IN REPLY REFER TO:  
NCPC File No. ZC #08-06A

RE: NCPC Comments on Proposed Text Amendments to DC Zoning Regulations

## **APPENDIX A**

### **Visual Modeling Study for North Capitol Street**

Standing at K Street Intersection

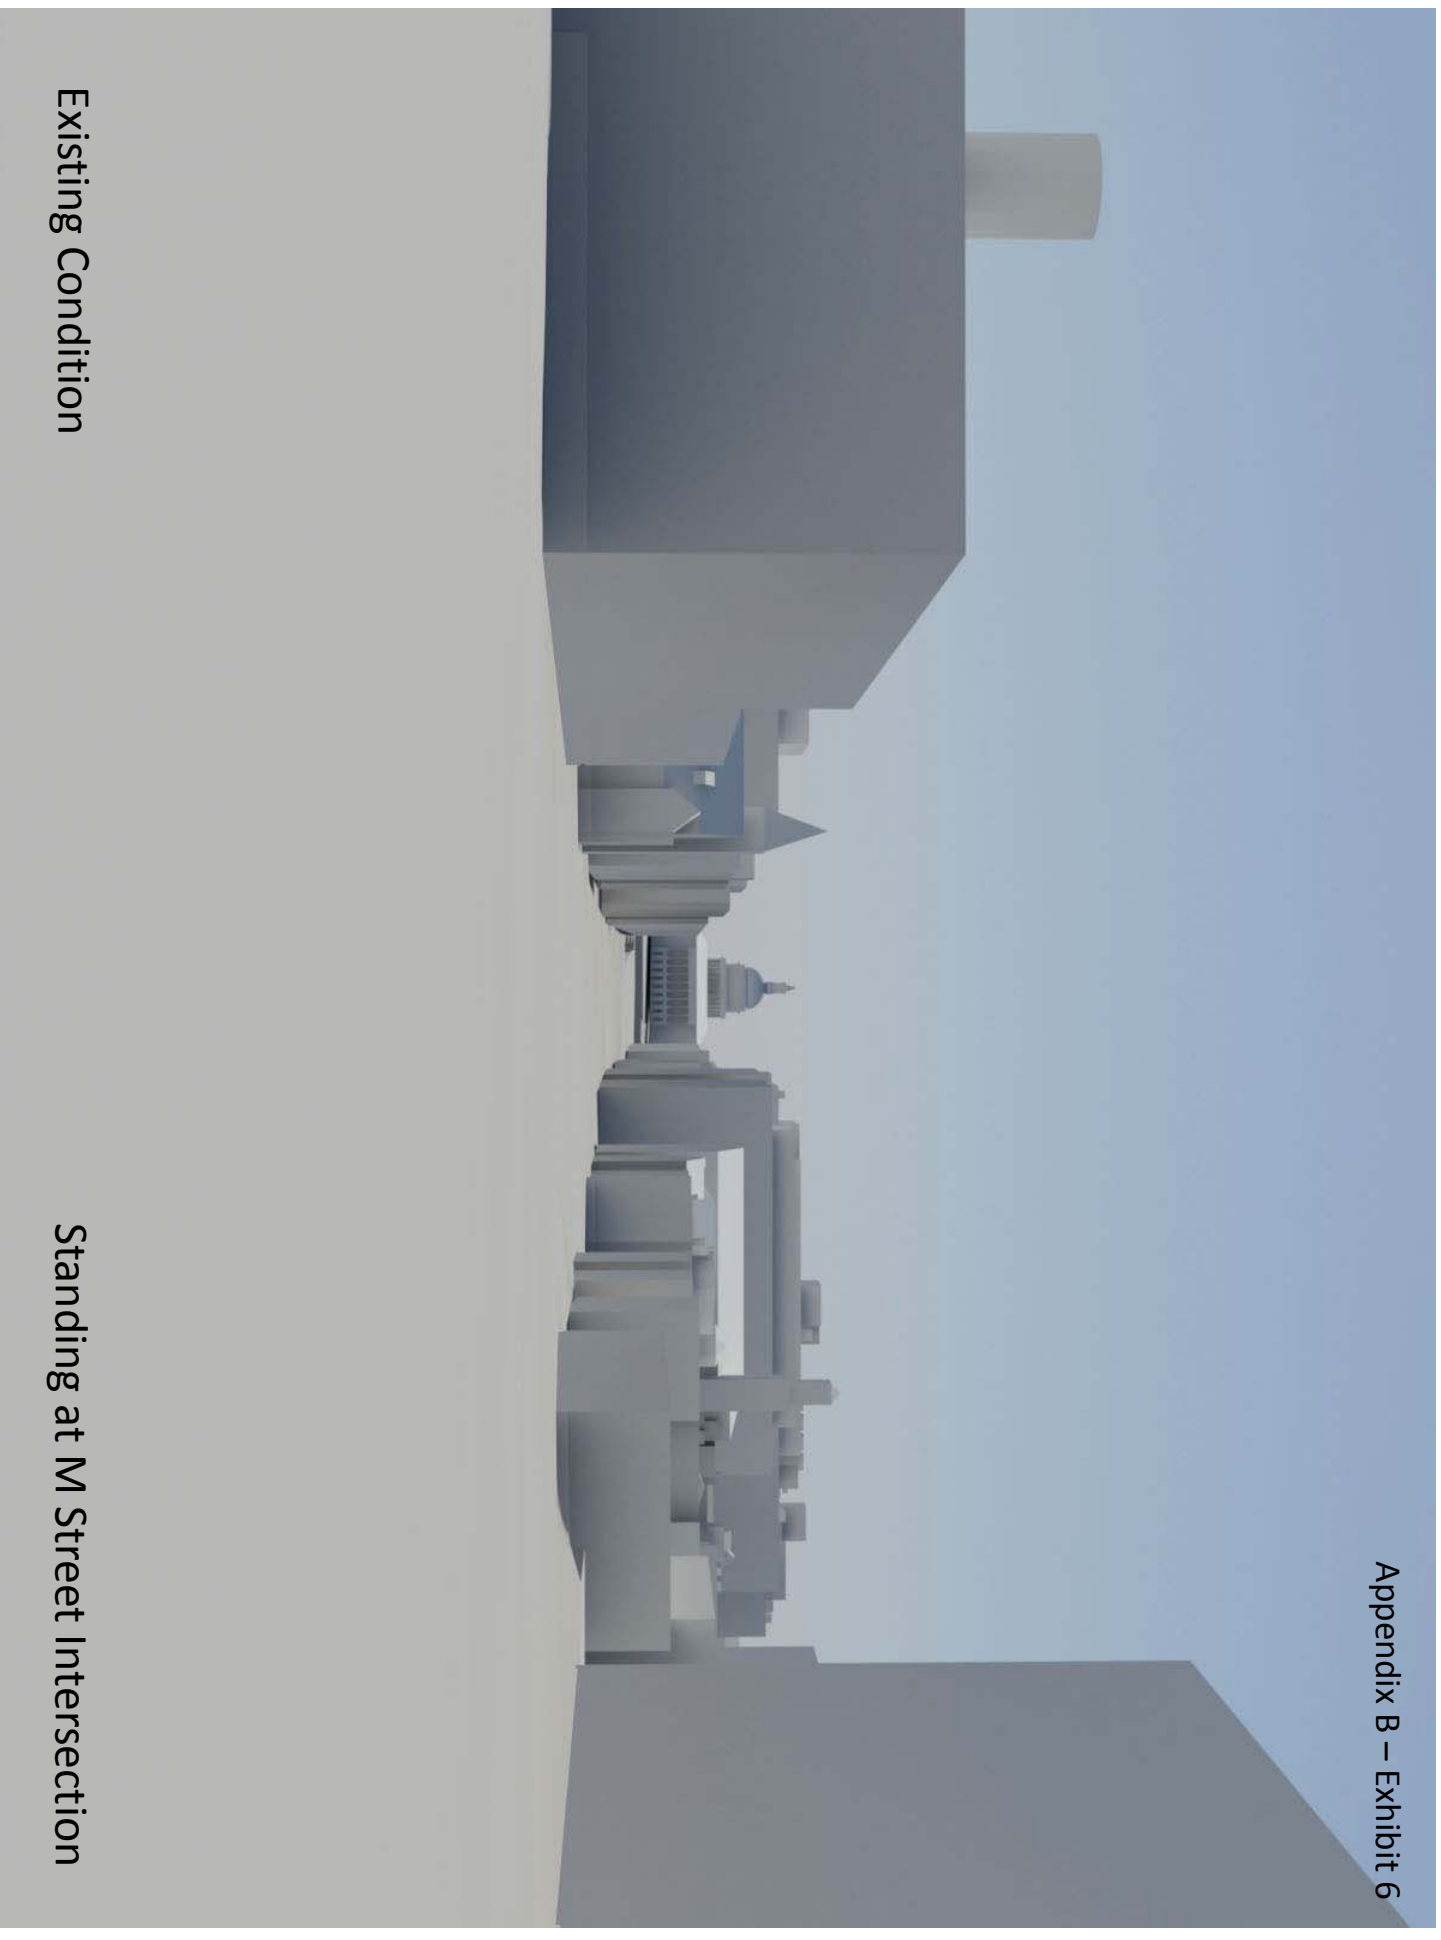
from K Street, an area that defines the composition of buildings and open spaces immediately to the north of the U.S. Capitol. *As proposed in the zoning update, there are four separate zones with different MOR heights that bisect North Capitol within this five-block area: D-5-B-1, D-4-B-1, D-3-B-1, and other areas not included in the Downtown Zone on the west side of the street north of G Street.* There are also several prominent federal properties and lands within this portion of North Capitol Street. The visual study considered strategies to create a cohesive building edge on these blocks and to ensure that the dome is not diminished by the proposed Matter of Right building heights.

The second visual study south of M Street illustrates the undefined edges along each of the blocks within the corridor, weakening the composition among buildings on either side of the street. This results in the impression that North Capitol is defined by the edges of the areas around it, rather than the preeminence of the dome and as a distinctive place unto itself. North Capitol Street should be developed as a distinct, cohesive corridor with urban design strategies that address these important transitions in density and land use, reinforce the quality of views to the Capitol, and promote the potential of this street as one of our city's most important gateways. Given the complexity of the land use conditions and urban design issues, NCPC staff does *not* make a recommendation for the blocks to the north of K Street. However, we welcome the opportunity to work with the Office of Planning through the Comprehensive Plan or more specific study, as appropriate, to consider urban design strategies for the entirety of North Capitol Street within the L'Enfant City.

Note: This conceptual visual study illustrates the undefined edges and difficult transitions between densities on either side of this corridor under proposed zoning. This potential building composition results in the impression that North Capitol is defined by the edges of the zones around it, rather than the preeminence of the dome and as a distinctive corridor. Given the complexity of the land use conditions and urban design issues, NCP staff does *not* make a recommendation for the blocks to the north of K Street, including the intersection shown in this illustration. However, we recommend that the urban design framework for North Capitol Street up to Florida Avenue be addressed through the Comprehensive Plan or more specific study, as appropriate. Future study should consider urban design strategies that address these important transitions in density and land use, reinforce the quality of views to the Capitol, and promote the potential of this street as one of our city's most important gateways.

- **On lands subject to zoning and not subject to any other height restrictions<sup>2</sup>: require a 1:1 step back at 110' feet within the Proposed D-5-B-1 Zone from Louisiana Avenue to K Street, NW. This step-back will ensure that the Capitol dome is not diminished by the proposed Matter of Right building heights and will also encourage a consistent cornice line in the blocks immediately adjacent to the Capitol.**

- **NCPC staff seeks to clarify the status of the D-3-B-1 Zone, which has a proposed MOR height of 110 feet. However, this is also identified as a receiving zone area. If, as a receiving zone, the maximum height allowed is 130 feet, staff recommends a 1:1 step-back at 110 feet. See Appendix B for an illustration.**

110' + additional 1:1 height step back  
for 20' + penthouse

A. Proposes a base height of 110' feet with a 1:1 height step back for any additional height for all areas where 130 feet may be achieved as a matter of right or within credit trading areas.

**Zoning Commission Design Review Map / NCPC Referral**

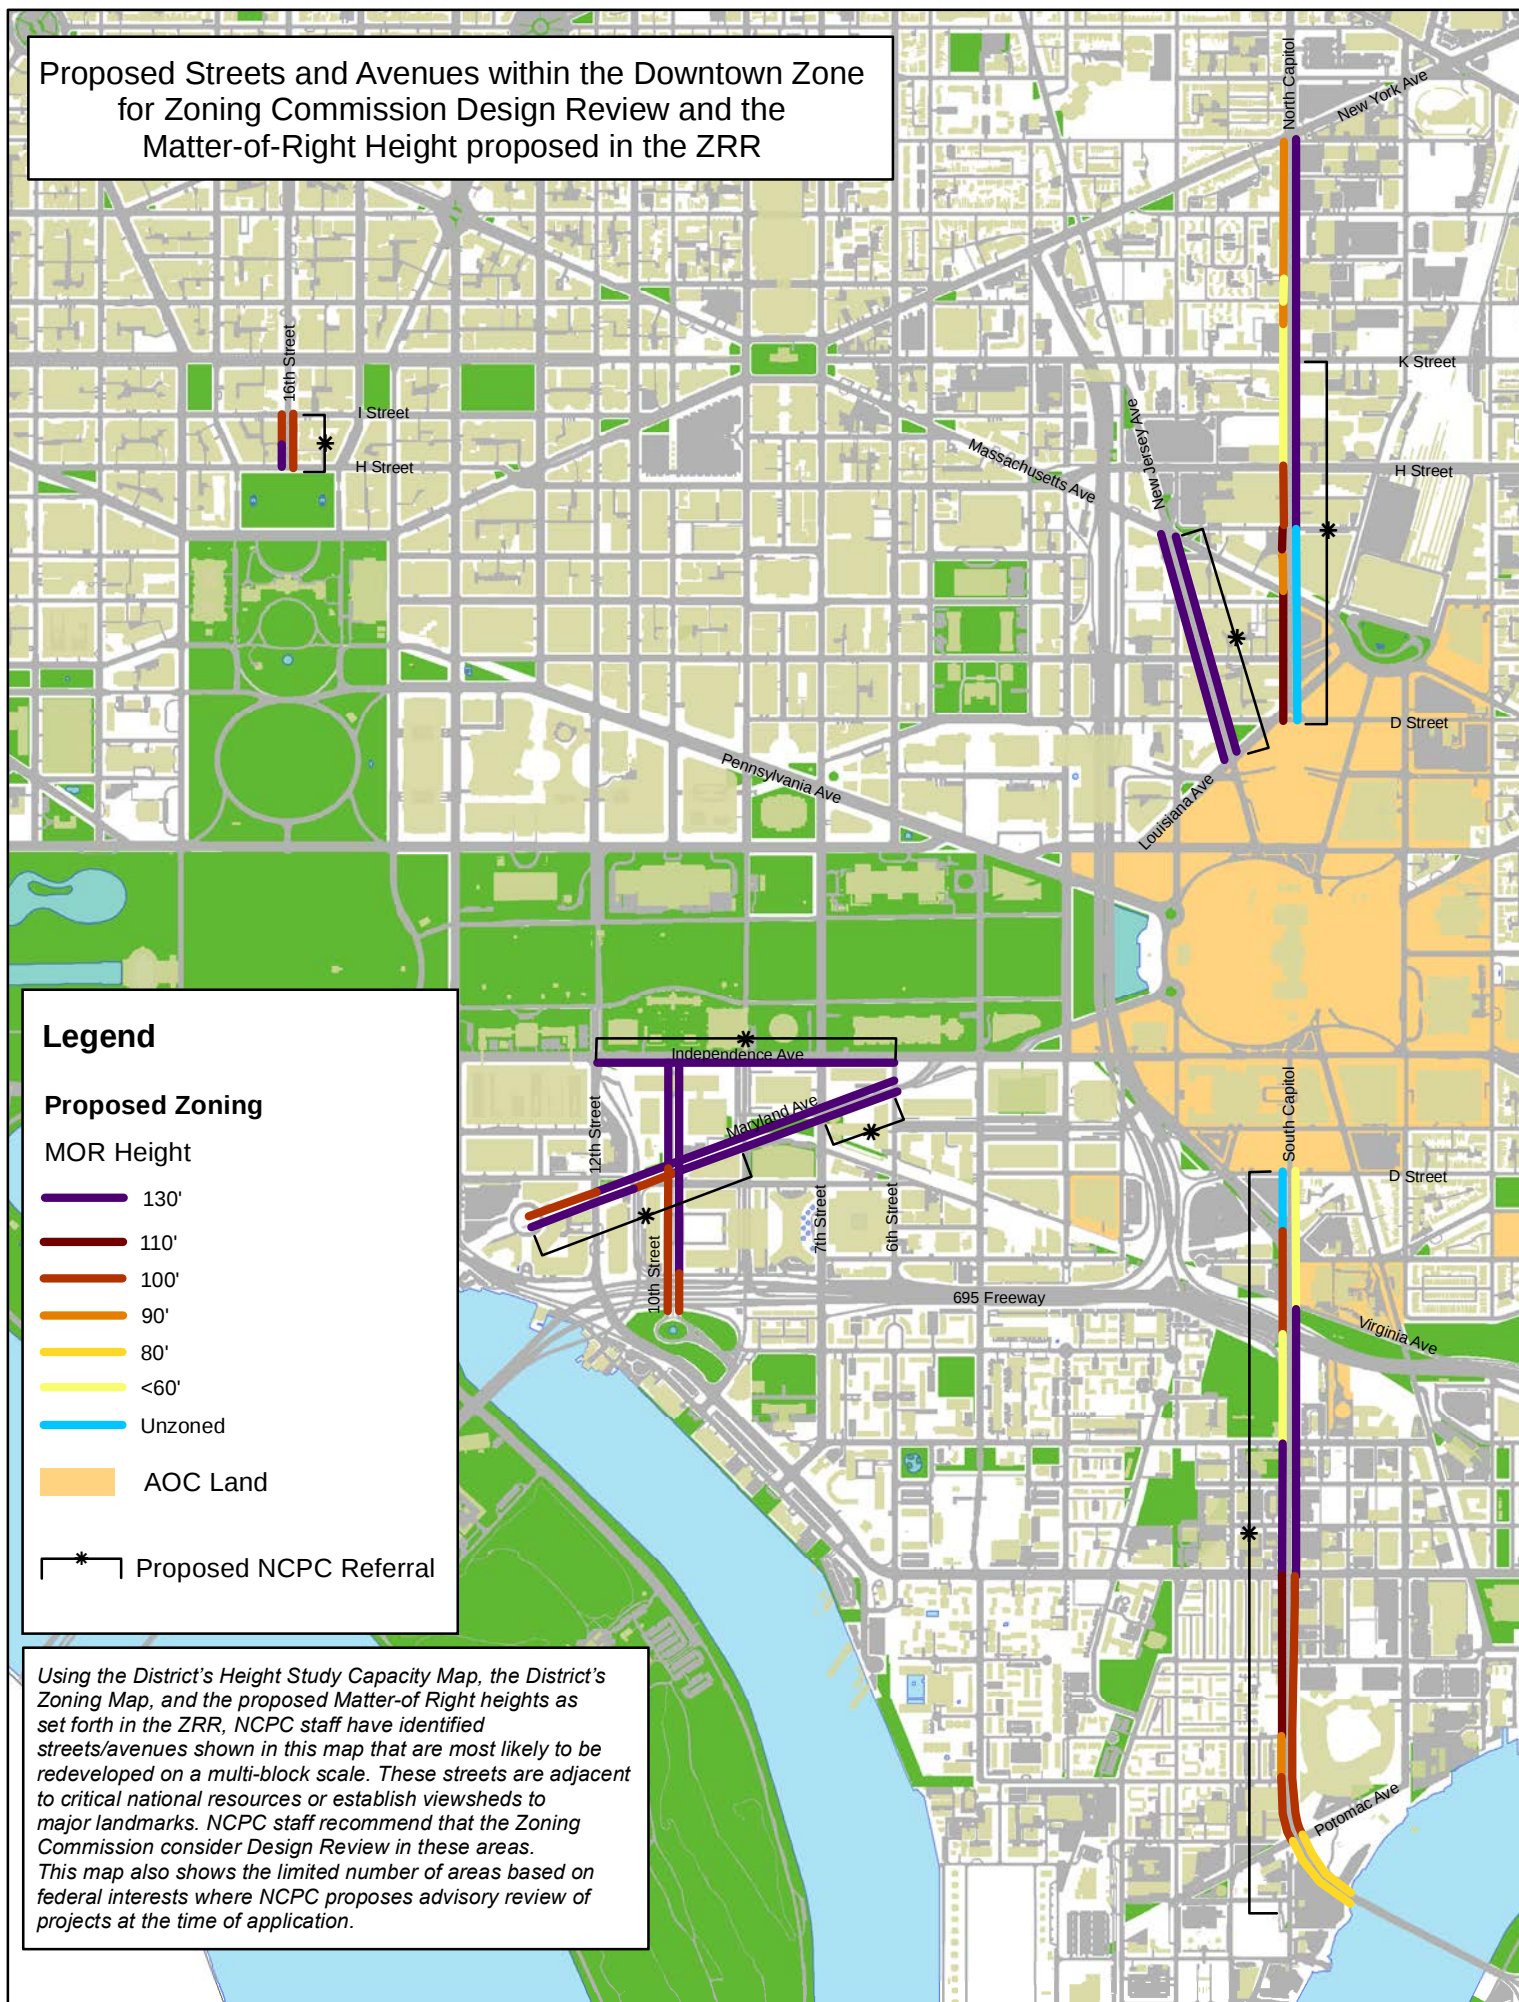
- **Expand the Zoning Commission's Downtown Design Review to include the blocks likely for redevelopment (as set forth above) and necessary to protect important national resources and balance local and national interests (Appendix C/Exhibit 3).**

- **Apply the design review criteria, Subtitle Z, Chapter 8 to the proposed Zoning Commission design review to the streets above (Appendix C/Exhibit 3).**

- **Lastly, NCPC respectfully requests that the Zoning Commission refer projects on the most important avenues/streets of national interest to NCPC for advisory review and comment at the time of application. These are shown in Appendix C/Exhibit 3 and include:**
